SERVICE BULLETIN

SUBJECT: ELECTRICAL POWER – Static Inverter AI² Part Number 1-002-0102-2173 – Modification.

TRANSMITTAL: Service Bulletin 1-002-0102-2173-24-41 Initial Release (Revision 0).

Figure 3

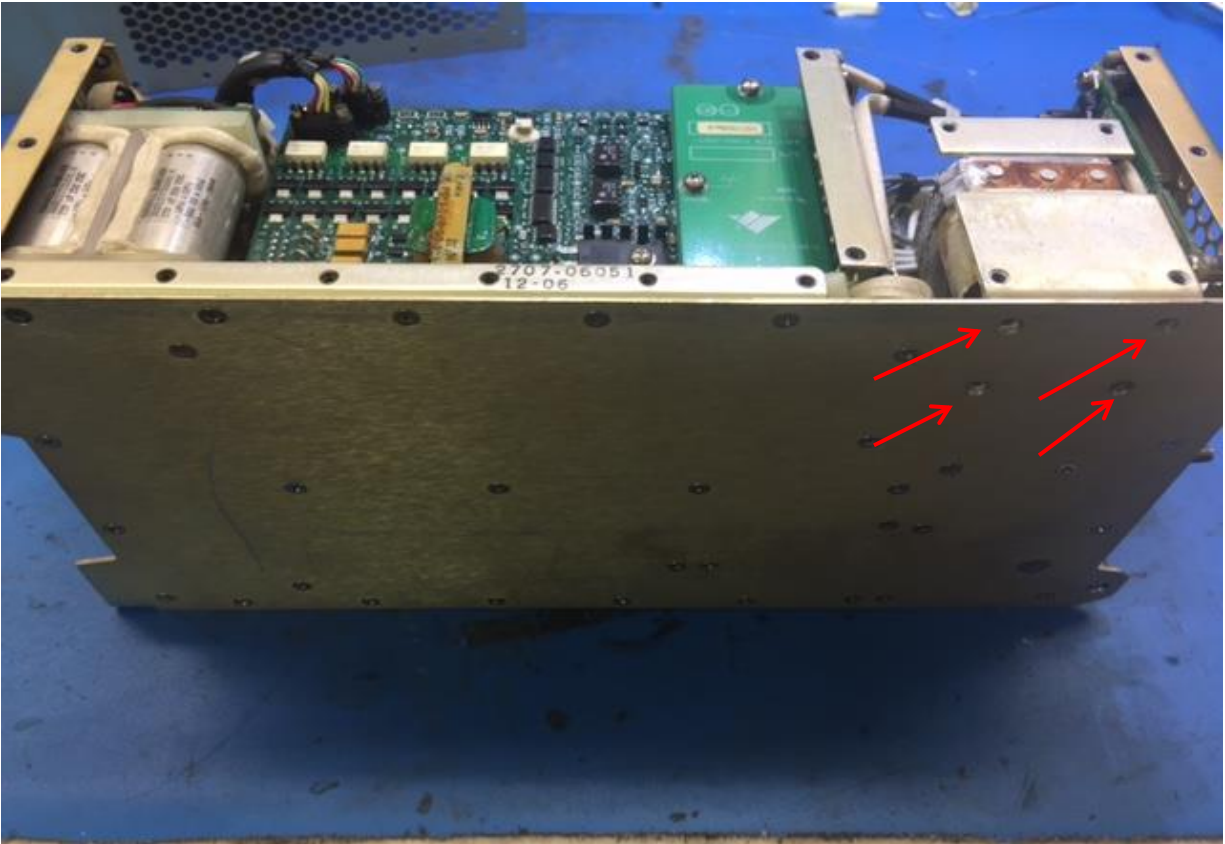
1. Remove 48 screws (51957-12) from the cover of the unit. (Figure 1).
2. Remove the cover from the unit. (Figure 2).
3. Disconnect the transformer from the base plate by removing (4) screws (24693-C2) from the base of the unit. (Figure 3, Figure 4).

Figure 5

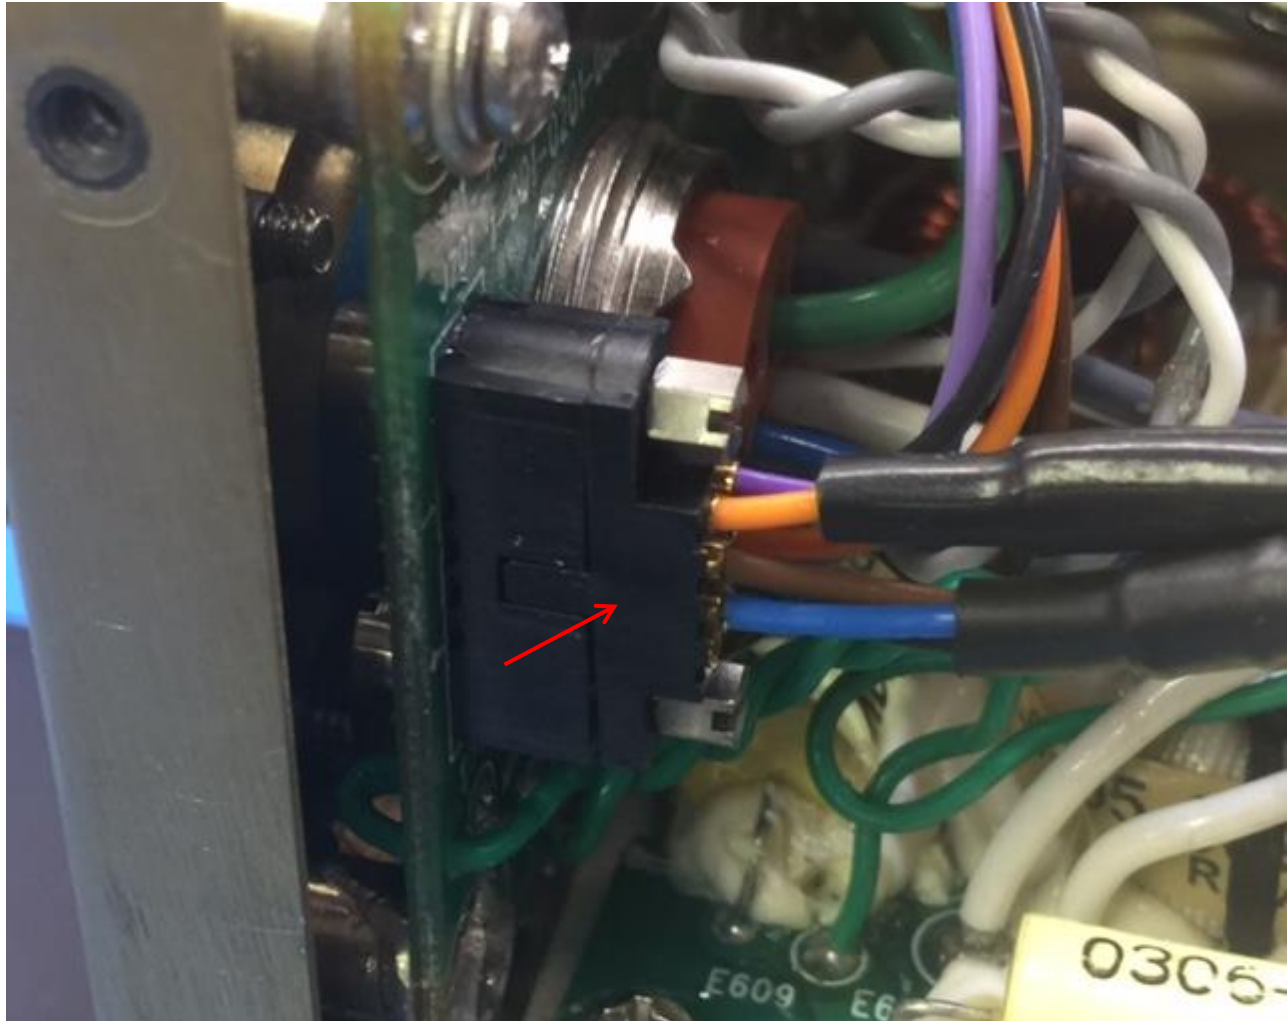
4. Disconnect the connector from the AC connector/ alarm assembly. (Figure 5, Figure 6).
5. Disconnect the wires/cables by de-soldering at locations E602, E603, E605, E608, E609 and E610 on the EMI Output board assembly (Soldering Iron tip JBC C245-741). (Figure 7, Figure 8, Figure 9, Figure 10, Figure 11, Figure 12).

Figure 13

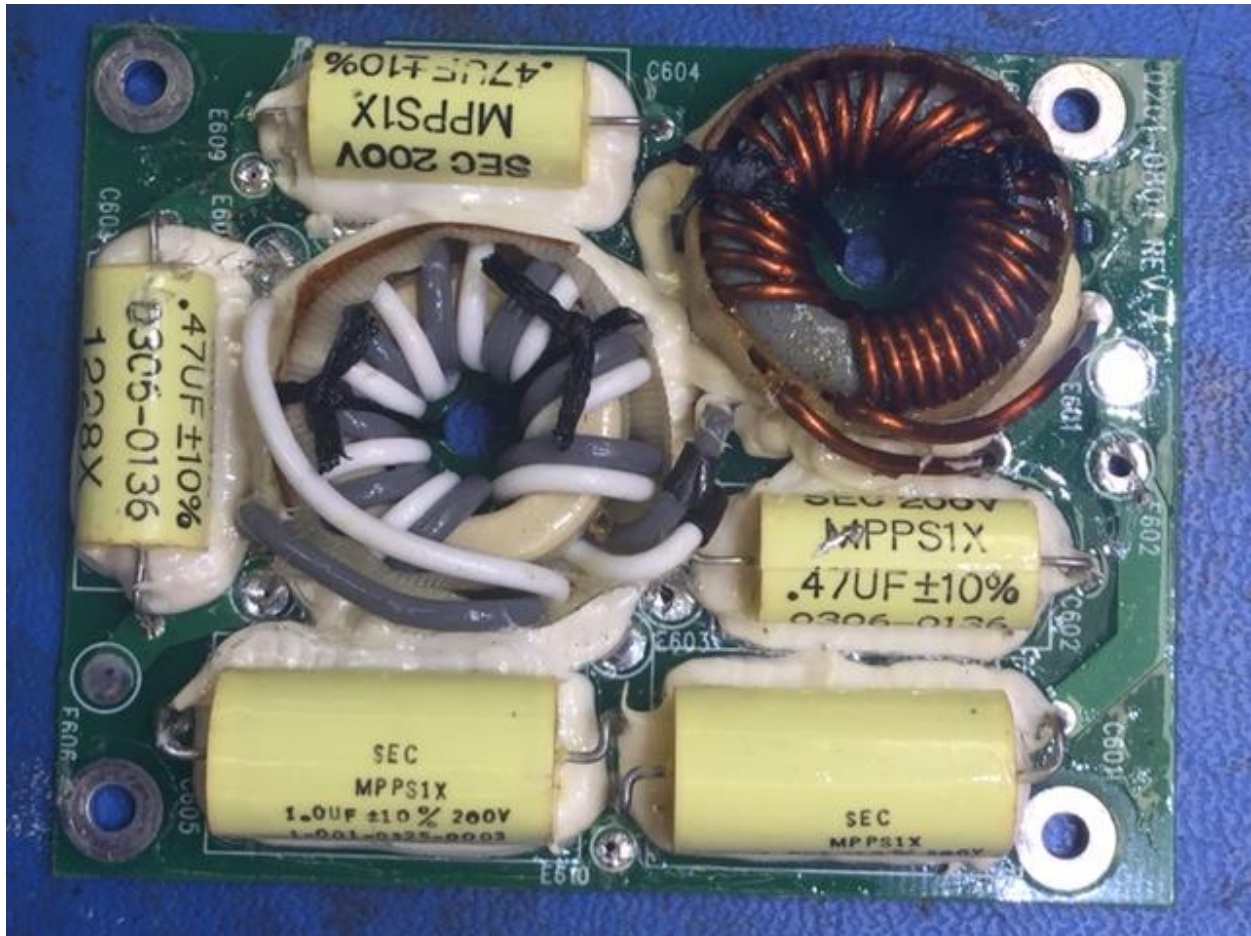
6. Remove EMI Output Assembly from EMI shield by removing (4) screws and washers. (Figure 13).
7. Remove capacitors by cutting leads with a cutter. (Figure 14).

Figure 15

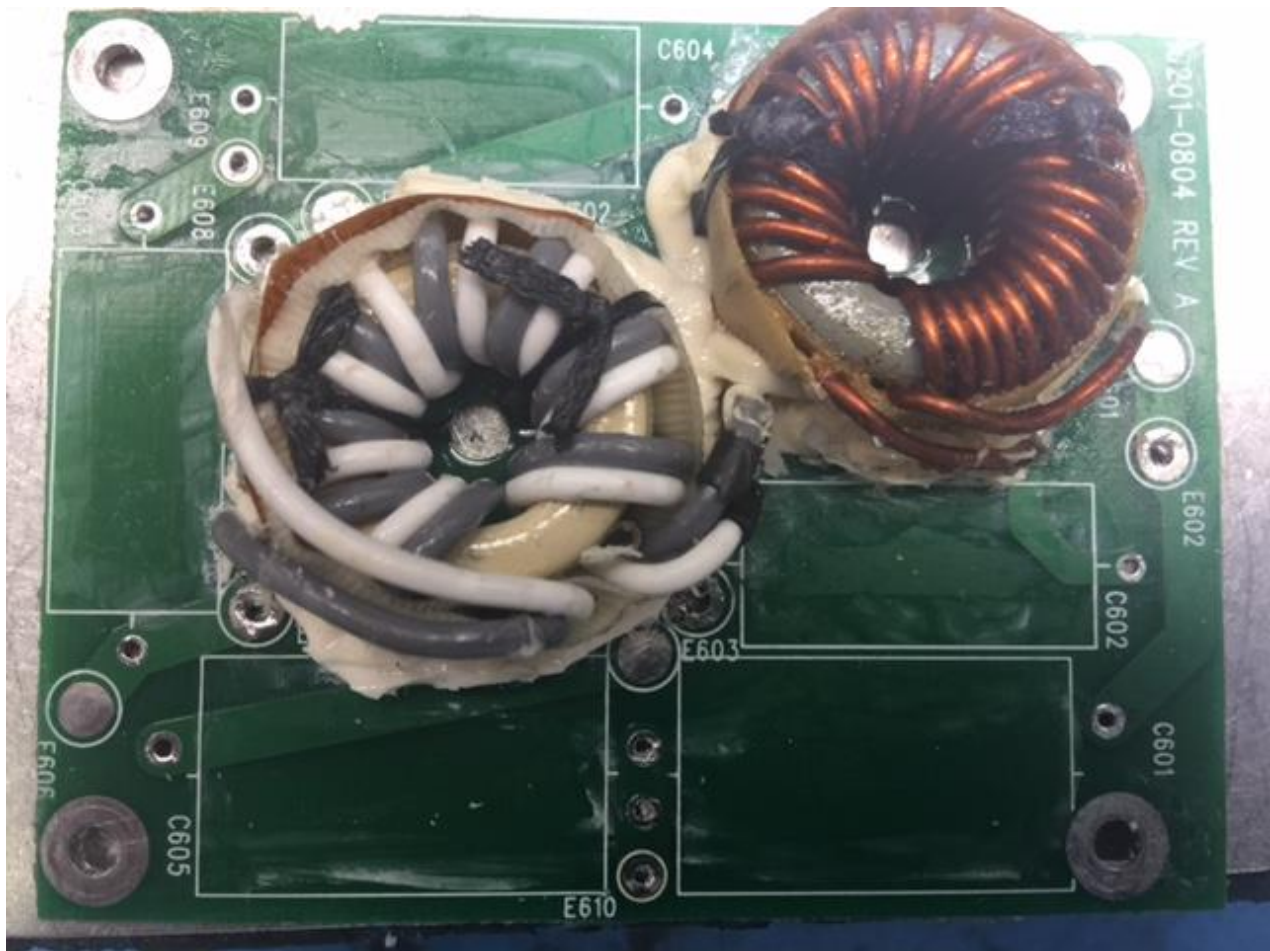
10. Manually clean the PCB holes with alcohol.
11. Apply thinner (1-001-2302-0019, T521-5L) over the old RTV and peel it off after 5 mins of dwell time. (Figure 15).

Figure 19

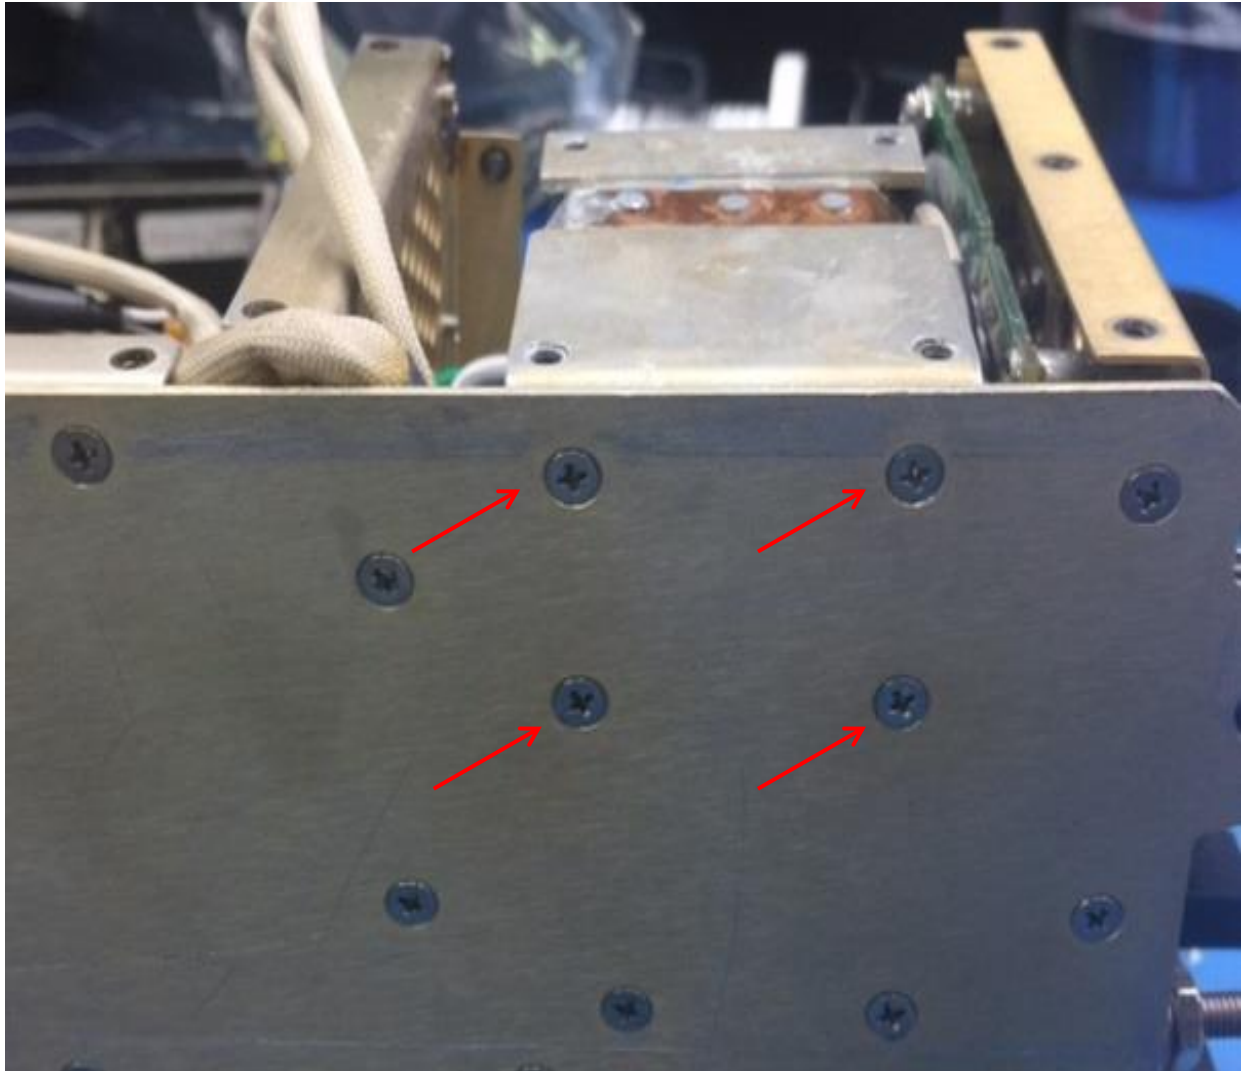
17. Apply conformal coating (MIL-I-46058) to the soldered areas.
18. Assemble transformer (1-005-0701-0470) to the base plate (1-002-0117-0097) using (4) screws (24693-C2). (Figure 19).
19. Connect the connector from the AC connector/alarm assembly (1-002-0108-0255). (Figure 20).
20. Secure the wires with grommet (1-001-0204-0029, Type 6/6). Secure the cables with cable tie (MS3367-5-9). (Figure 21).
21. Attach cover on to the unit using (48) screws (51957-12). (Figure 1).
